**Australian Government**  
**National Capital Authority**

## **CONSULTATION REPORT**

**National Capital Plan Draft Amendment 97 - Block 7 Section 4  
Yarralumla (former Australian Forestry School)**

February 2024

***Realignment Bus 57 Route***

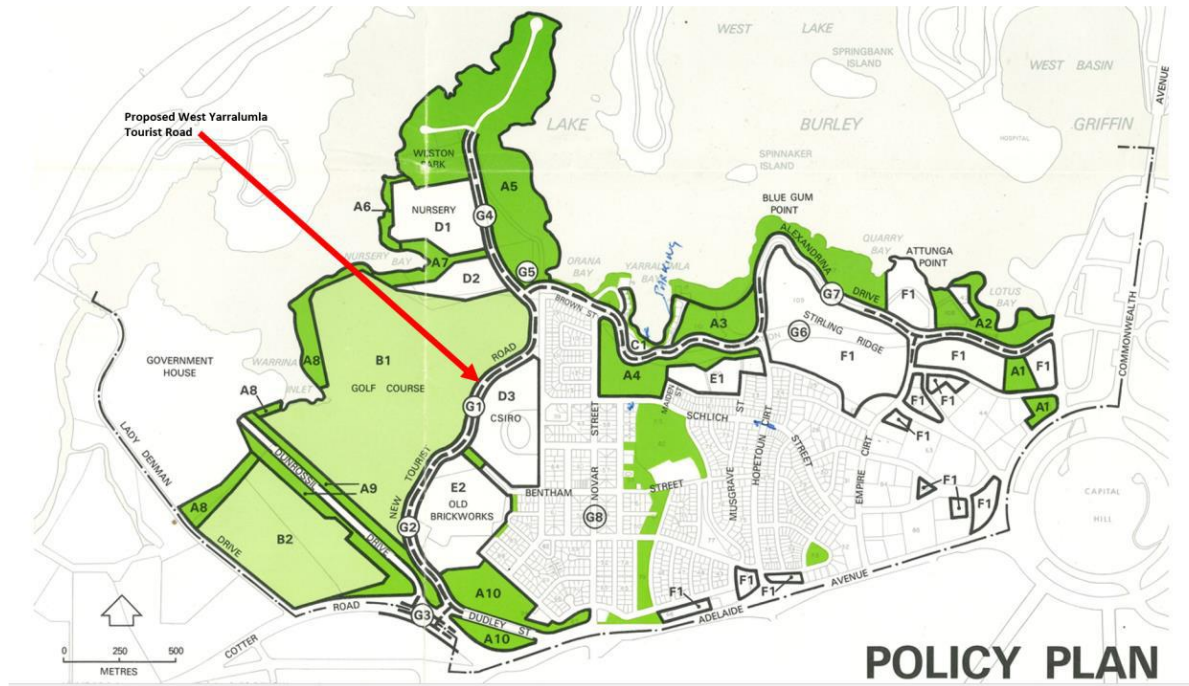
In addition the Traffic Assessment suggests for improved public transport the realignment of the Bus Route 57 to also travel via the Forestry Place Development on Banks Street and through Benthams Street at the Yarralumla Shops.

naturally a matter for TCCS to review at their discretion and we expect any such review would occur as part of comprehensive bus route planning associated with Light Rail stage 2.

***Australian Forestry School abuts 4m wide Wilf Crane Crescent***

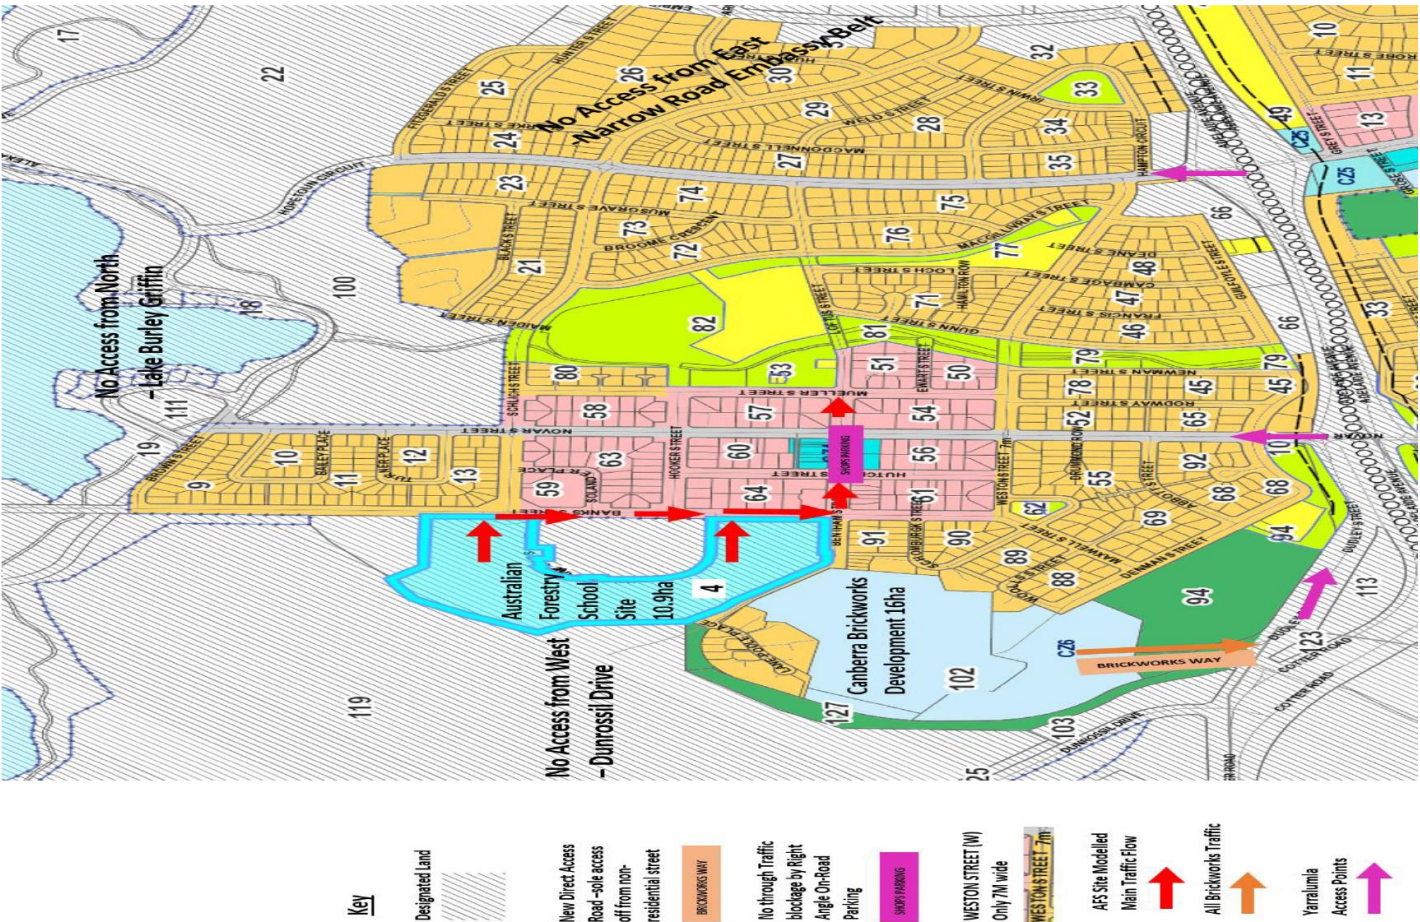
***Australian Forestry School Wilf Crane Crescent one-way traffic***

It is intended to dedicate Wilf Crane Crescent to the Territory Government during the course of the redevelopment and in this process, any potential narrowing of Wilf Crane Crescent at the northern end near the former Forestry School as discussed in response to YRA Executive Summary comment 6, is proposed to be addressed and subject to a future works approval.

Figure 2.1 – Locations of trips made by South Canberra residents

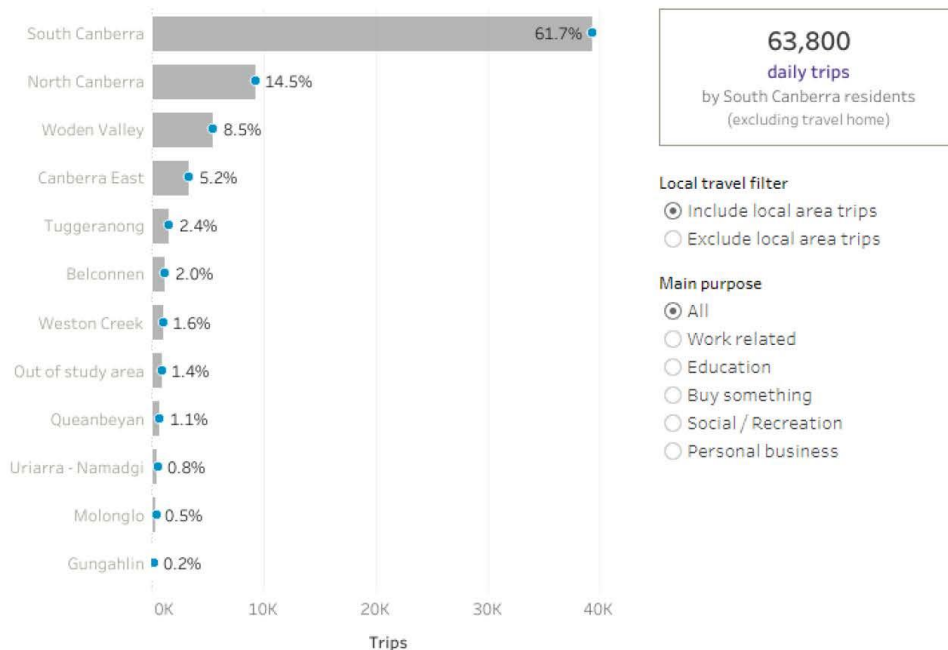
*5. The Traffic Assessment does not provide a sound basis from which to assess the scale and impact of the traffic that will be generated from the Forestry Place Development. The application of the intersection counts and traffic assessment modelling to Yarralumla is fundamentally flawed in the Transport Impact Assessment of the Forestry Place Development. The parameters and assumptions of the modelling do not align with the local characteristics, street hierarchy and traffic flows of Yarralumla. For example, Yarralumla has high out-of-suburb traffic levels for childcare centres, the primary school (80% non-resident), churches and the Royal Canberra Golf Club. Weekend traffic in Yarralumla is 17%-56% higher than weekday traffic (Banks Street 2015-16), especially in summer, as Yarralumla is the access point for users of Weston Park and Lake Burley Griffin and their attractions. For example, the 2nd December 2023 Rowing Regatta had 753 competitors, plus support crews, family and spectators, many from interstate. This results in a high level of Yarralumla traffic being visitors not residents.*

As discussed in Section 7.4 of the Transport Assessment, to ascertain the likely number of internal trips to Yarralumla, guidance has been sought from household travel surveys completed by the ACT government in 2017. The surveys indicate that between 35 per cent and 75 per cent of all trip types can be serviced locally within the South Canberra district area. Given the data was based on the 2017 household travel survey, comparable data has been extracted from the most recent household travel survey completed in 2022, reproduced in Figure 2.1. As shown, 62 per cent of daily trips made by Canberra residents can be serviced locally within the South Canberra district area, consistent with 2017 results.
